SERVICE BULLETIN

PRODUCT: Computer Monitor
BULLETIN: Monitor 95-006
MODEL: Samtron SC-428PS

SUBJECT: Vertical Circuit Modification

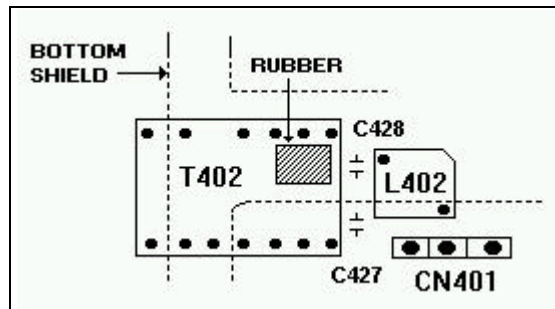
BACKGROUND: A whistling sound is created from harmonic noise generated between T402, L402, and the main PCB near the Flyback Transformer.

SOLUTION: Add a piece of rubber to insulate the main PCB solder side from the bottom metal shield. See Illustration below showing the section of the PCB where the rubber will be located.

Figure 1

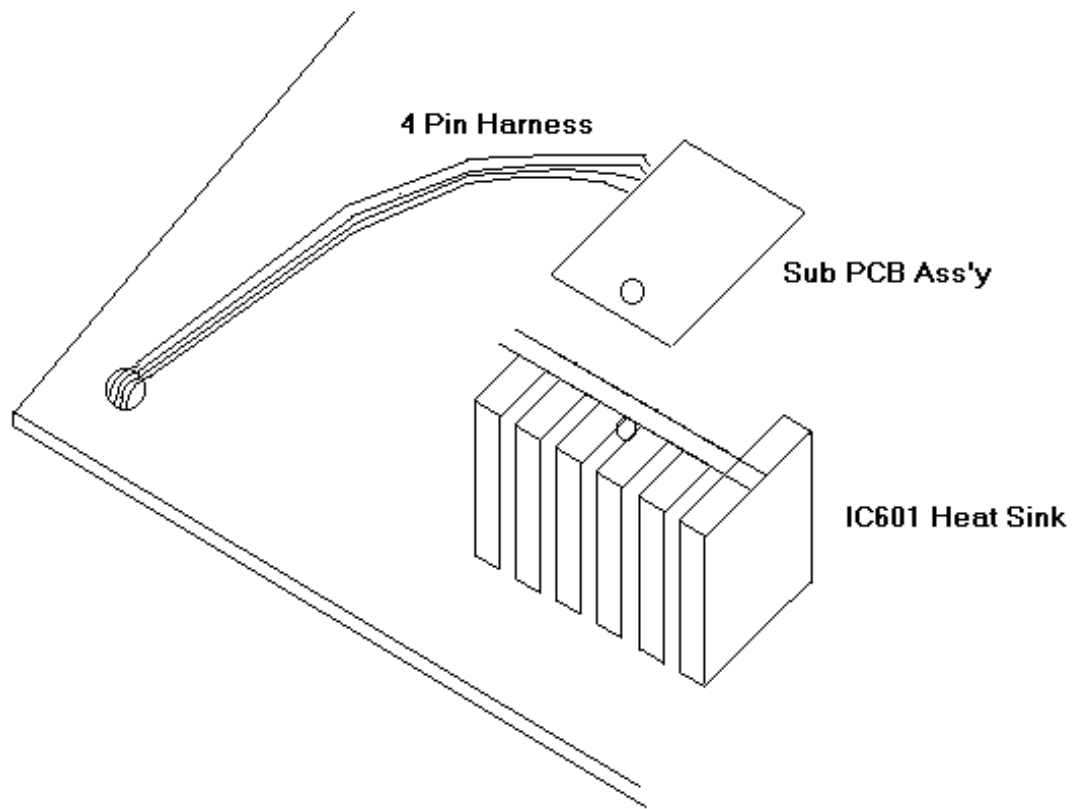
BACKGROUND: Q407 fails due to a transient pulse and current when mode switching from DOS to Windows. This occurs with a Matrox video card installed in the computer.

SOLUTION: Add a sub-PCB assembly as in figures 1 and 2 and a snubbing circuit for the horizontal output as in figure 3.
